Project	<b>IEEE 802.16 Broadband Wireless Access Working Group</b> < <a href="http://ieee802.org/16">http://ieee802.org/16</a> >	
Title	<b>AAS enhancements for OFDMA PHY</b>	
Date Submitted	<b>2004-04-29</b>	
Source(s)	<p>Dale Branlund, Lalit Kotecha, Mike Webb BeamReach Networks</p> <p>Adam Kerr, Paul Petrus ArrayComm Inc.</p> <p>Zion Hadad, Yigal Leiba Runcom Technologies Ltd.</p> <p>Jose Puthenkulam<sup>3</sup> Intel Corp.</p> <p>Panyuh Joo, Seungjoo Maeng, Jaeho Jeon, Soonyoung Yoon, Jeong-Heon Kim, Jaehyok Lee, Myungkwang Byun, Inseok Hwang, Jaehee Cho, Jiho Jang, Sanghoon Sung, Samsung Electronics Co. Ltd.</p> <p>Choongil Yeh, Hyoungsoo Lim, Yuro Lee, Jongee Oh, DongSeung Kwon, ETRI</p>	<p>mailto: dbranlund@beamreachnetworks.com <a href="mailto:adam@arraycomm.com">adam@arraycomm.com</a> <a href="mailto:zionh@runcom.co.il">zionh@runcom.co.il</a> lkotecha@beamreachnetworks.com jose.p.puthenkulam@intel.com petrus@arraycomm.com mwebb@beamreachnetworks.com yigall@runcom.co.il panyuh@samsung.com lim@etri.re.kr</p>

Re:	IEEE P802.16-REVd/D4-2003	
Abstract	This contribution introduces AAS enhancements for OFDMA PHY as an optional feature	
Purpose	Adopt into P802.16d/D5 draft.	
Notice

Figure 1—Example of allocation for AAS-DLFP

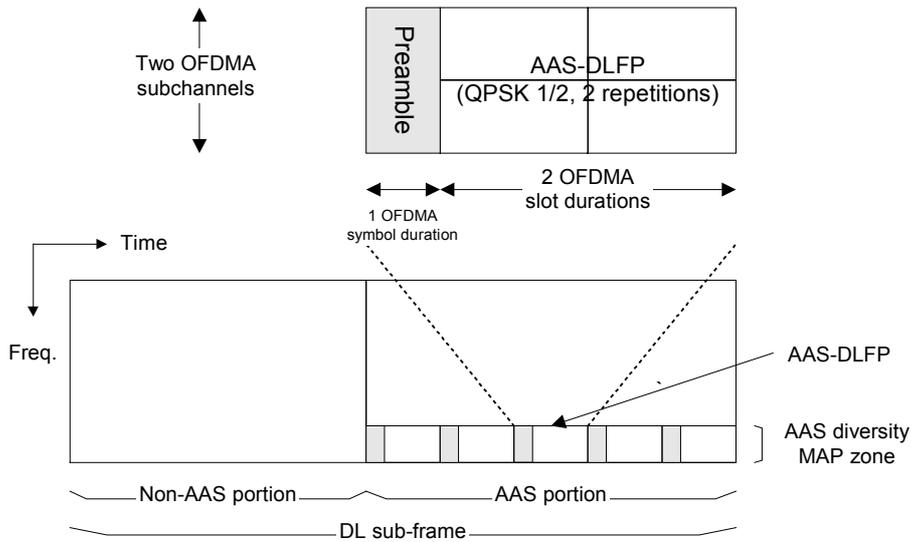
The two highest numbered subchannels of the DL frame may be dedicated at the discretion of the BS for the AAS Diversity-Map Zone in PUSC, FUSC and optional FUSC permutation. In the AMC permutation, the 4<sup>th</sup> and (N-4)<sup>th</sup> subchannels of the total N subchannels of the DL frame may be dedicated at the discretion of the BS for the AAS Diversity-Map Zone. For AMC permutation, each subchannel for the AAS diversity MAP consists of 3 bins by 2 symbol. When these subchannels are used for this purpose, they shall not be allocated in the normal DL-MAP message and shall be used only on the AAS portion of the DL sub-frame. These sub-channels will be used to transmit the AAS-DLFP() whose physical construction is shown in Figure 1.

Figure 2: AAS Diversity Map Frame Structure

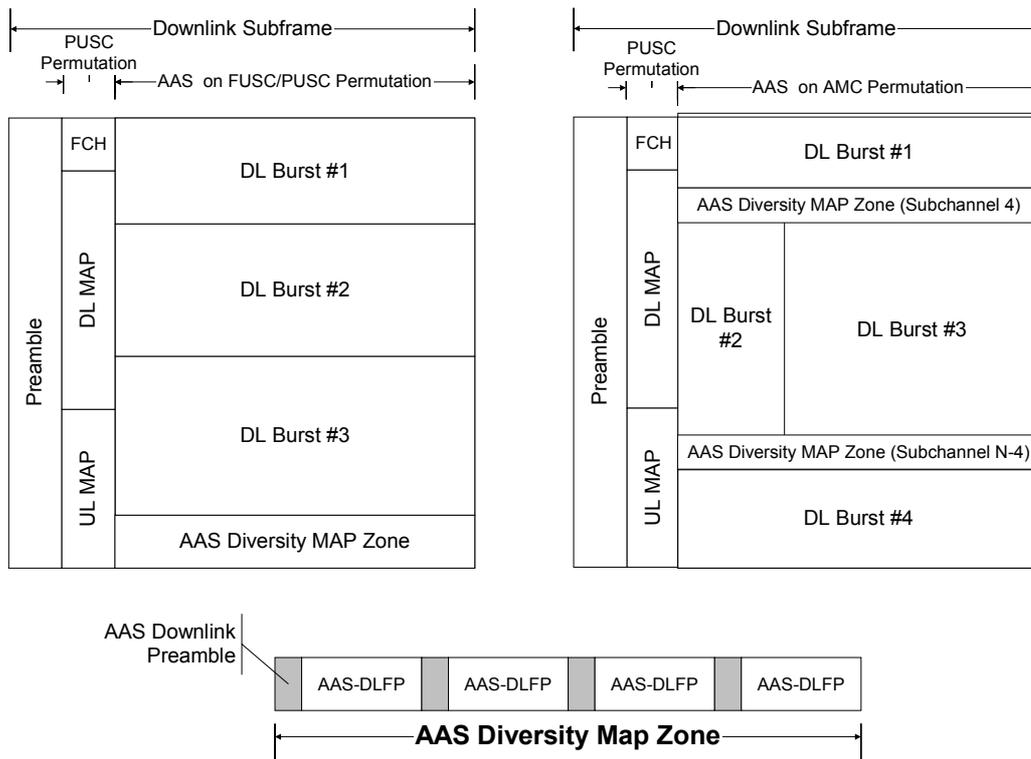
The AAS portion in the DL (or UL) may be transmitted either by the FUSC/PUSC permutation or by the optional AMC permutation. Figure 2 shows an example of a DL sub-frame for each of these two possible variations.
